Livonia Public Schools

Central Office
Generator Upgrades

Addendum #1

ES100

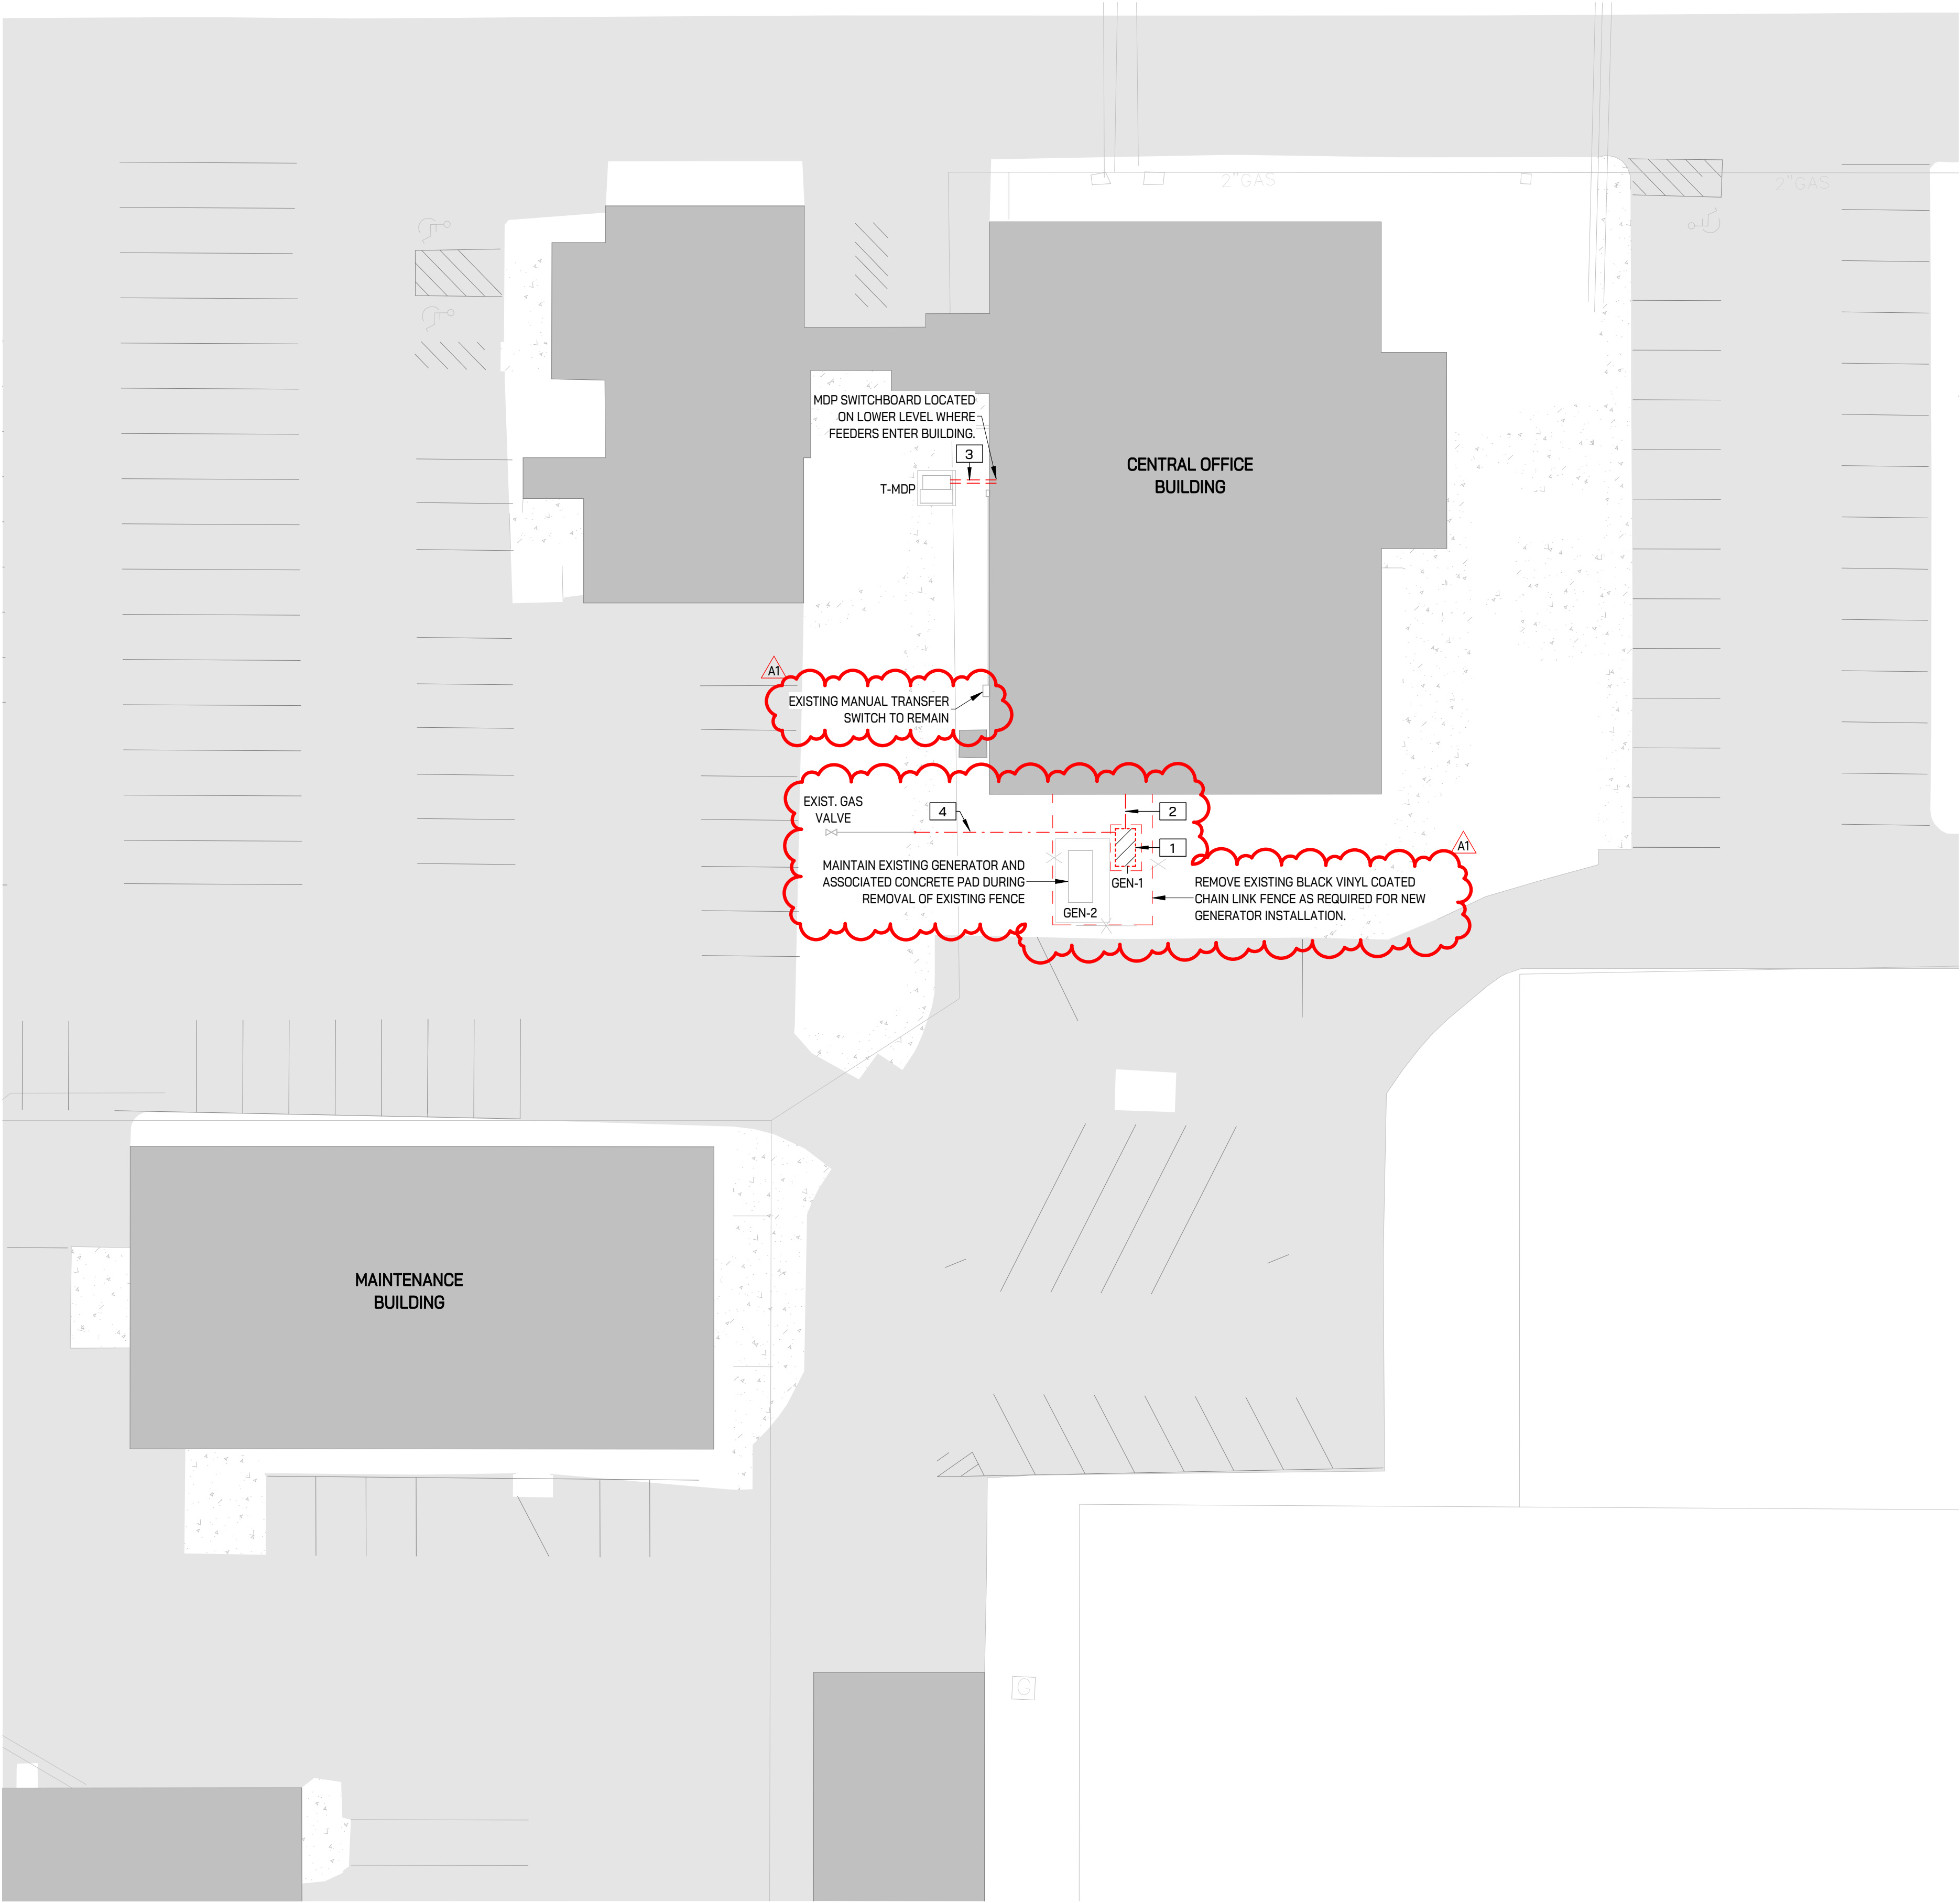
- PROVIDE (3) 20A/1P SQUARE D CIRCUIT BREAKERS TO AVAILABLE SPACE IN PANELBOARD FOR GENERATOR ACCESSORY CIRCUITS. PROVIDE GENERATOR AND ATS-MDP ANNUNCIATOR PANELS IN BUILDING SUPERVISOR'S OFFICE. ROUTE CONDUIT AND CABLING FROM GENERATOR AND TRANSFER SWITCH AS RECOMMENDED BY MANUFACTURER.

E100

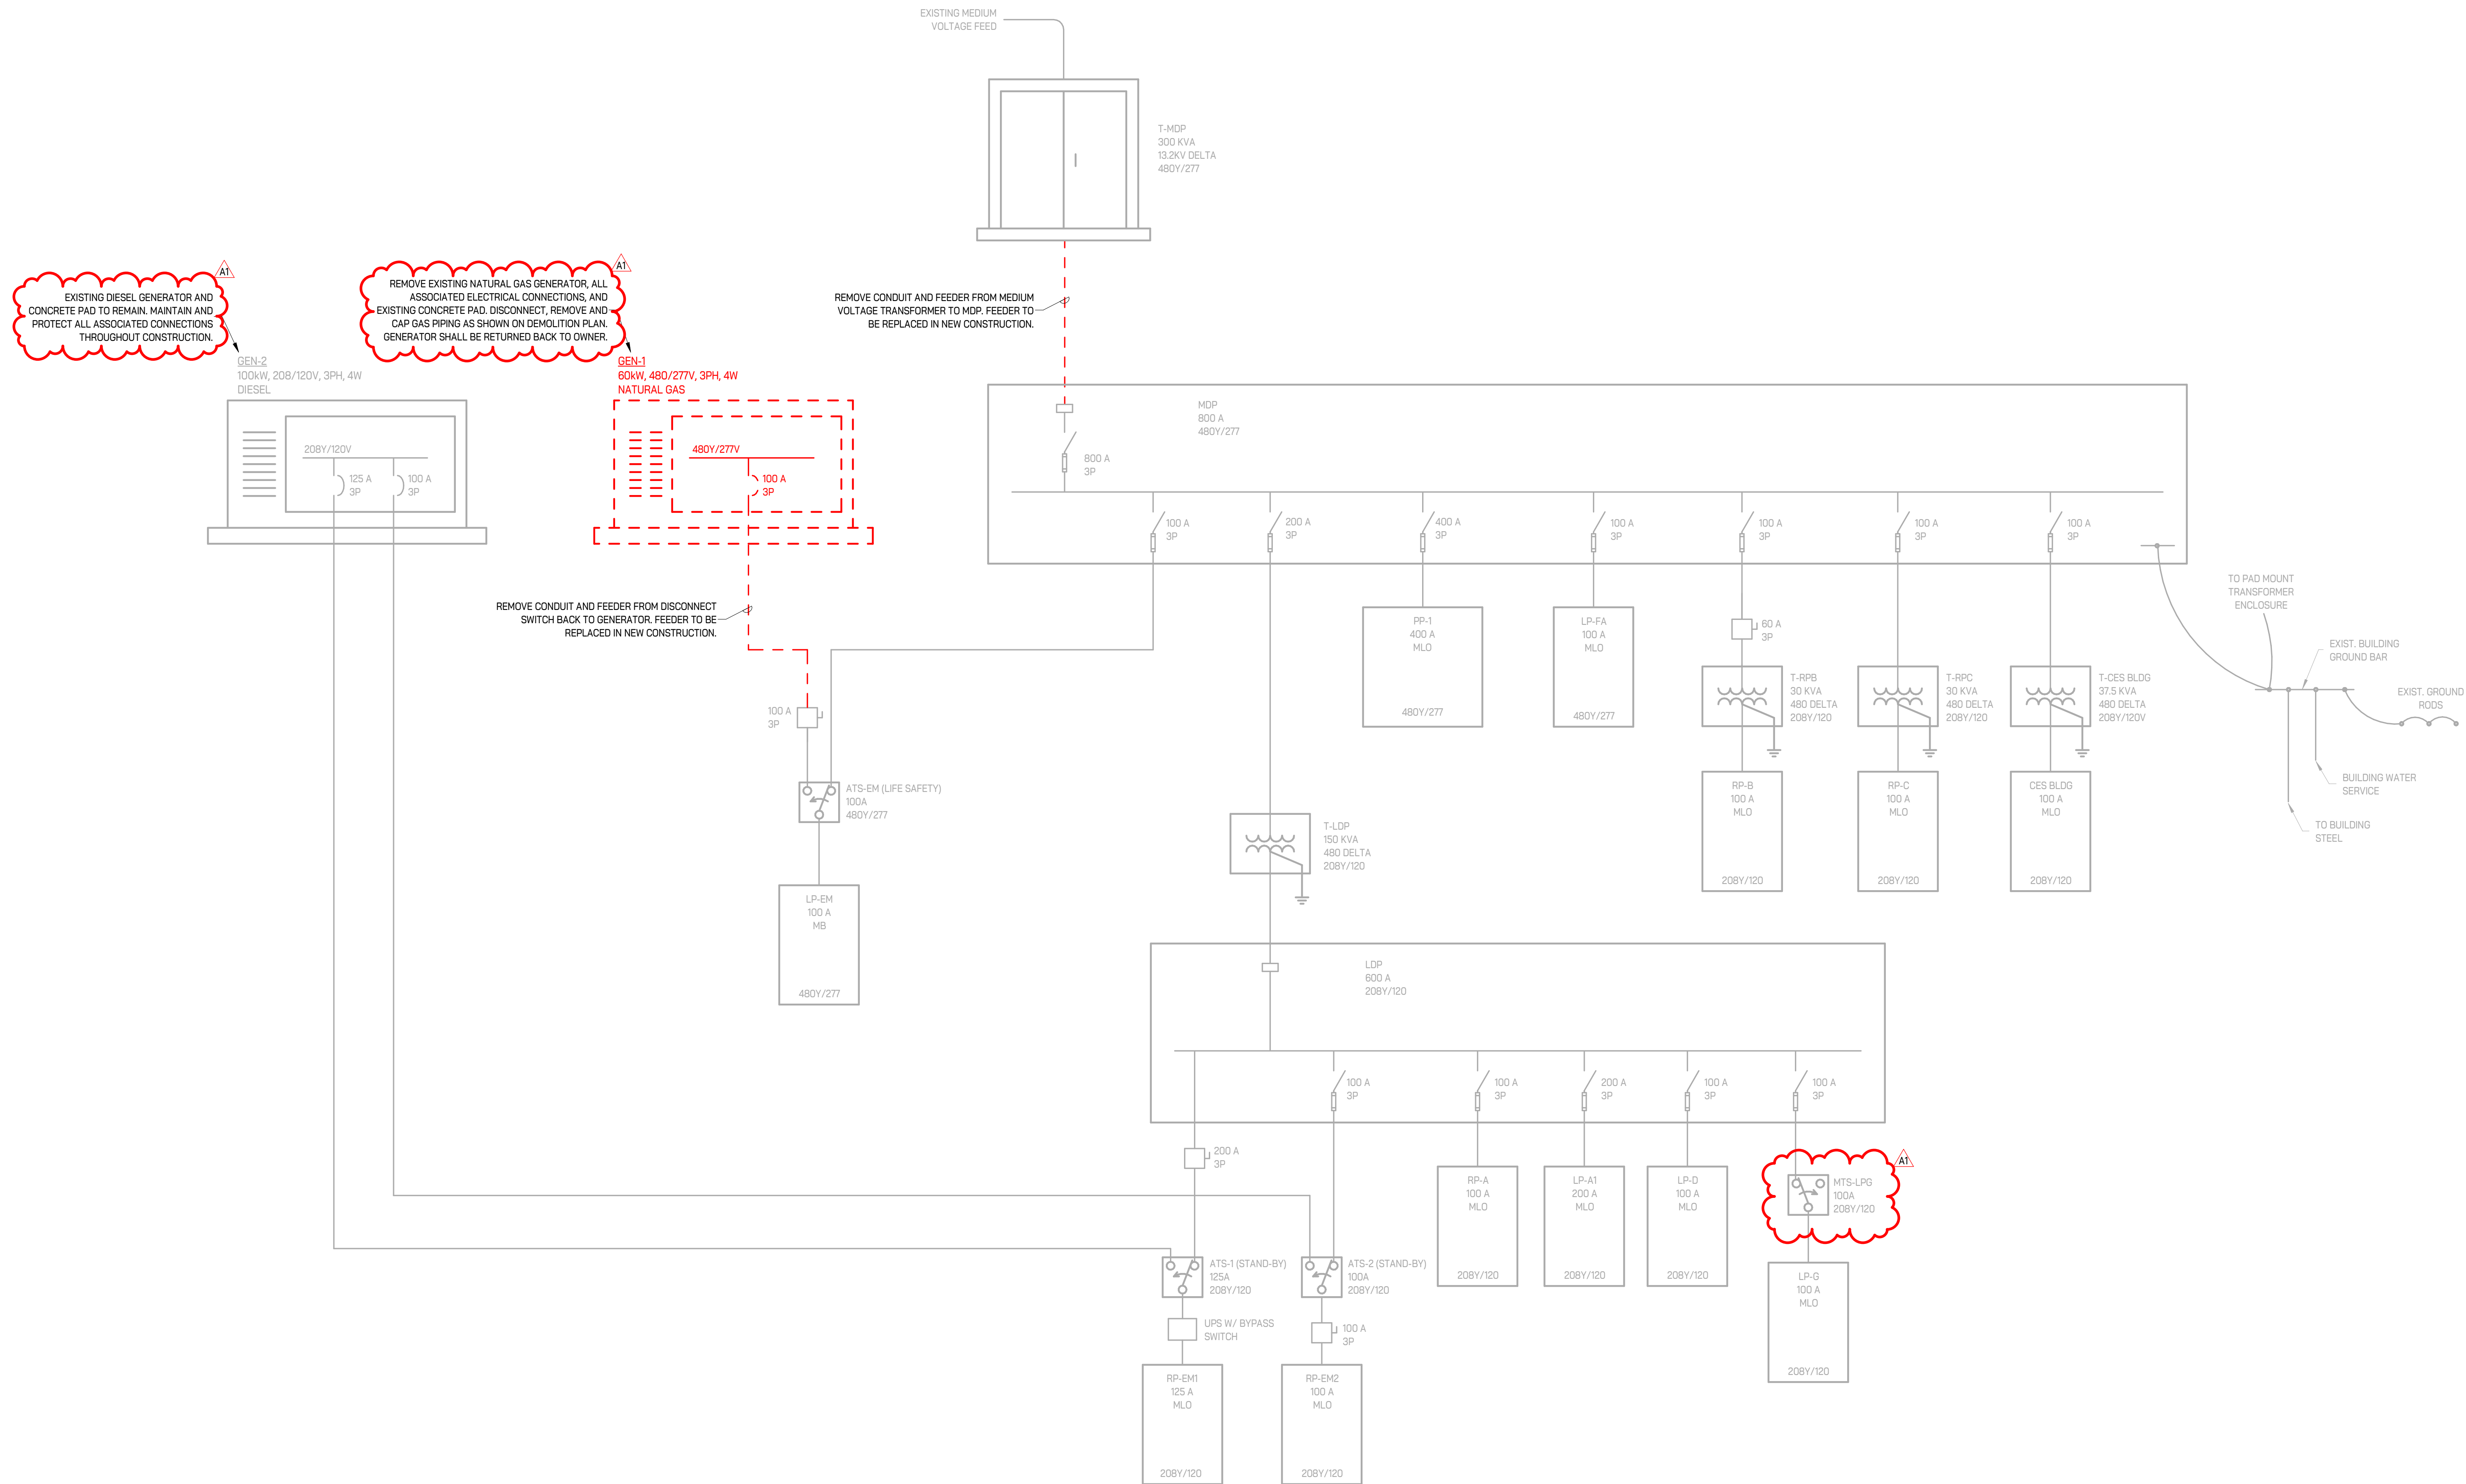
- 8 PROVIDE (3) 20A/1P SQUARE D CIRCUIT BREAKERS TO AVAILABLE SPACE IN PANELBOARD FOR GENERATOR ACCESSORY CIRCUITS.
- 9 PROVIDE GENERATOR AND ATS-MDP ANNUNCIATOR PANELS IN BUILDING SUPERVISOR'S OFFICE. ROUTE CONDUIT AND CABLING FROM GENERATOR AND TRANSFER SWITCH AS RECOMMENDED BY MANUFACTURER.
